AXIe 1.0 Specification Errata

Revision 1.0

April 28, 2011

Figure 6-1: AXIe local bus backplane topology

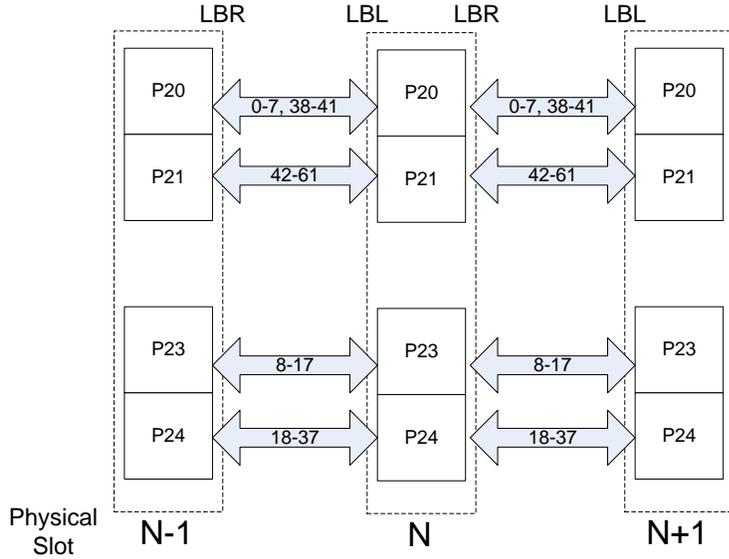
Figure 6-1 (page 37) and Table 6-5 (page 43) incorrectly portray the AXIe Local bus pair numbers on connectors J20/P20 and J24/P24. Connector J20/P20 actually has local bus pairs 0-7 and 38-41. Connector J24/P24 actually has local bus pairs 18-37. The corrected Figure 6-1 is:
